TAL-CO SUPPLEMENTAL INSTRUCTION #31			
Project Name:	RW TOMLINSON - NEW HEAD OFFICE		
Project Location:	100 City Gate Drive, Ottawa, Ontario		
ARCH. SI #:	N/A	Issued By:	Chris Simpson
STRUC. SI #:	N/A	Date Issued:	February 17, 2016
MECH. SI #:	N/A	Revision #:	N/A
ELEC. SI #:	CCN-E2, CCN-E3	Revision Date:	N/A

**Title:** Additional Walker Duct and Kitchen Revisions for Ground Floor/ Electrical Revisions For Mechanical Equipment

CCN E-2

CCN E-3

##### 1. Walker Duct Layout – Additions

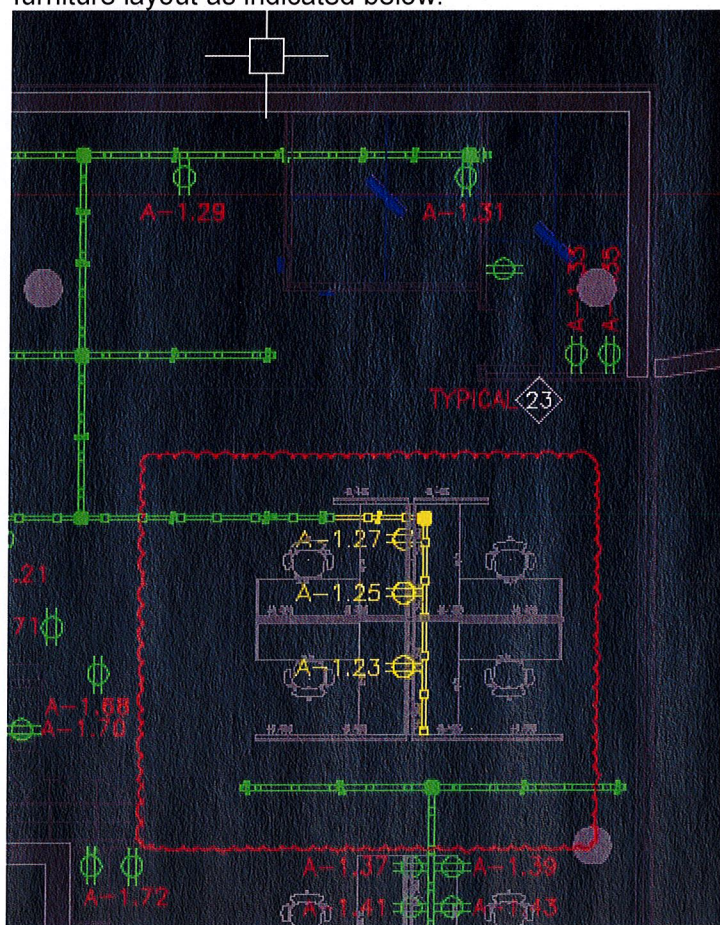
Provide the additional walker duct sections/length to accommodate revised furniture layout as indicated below:
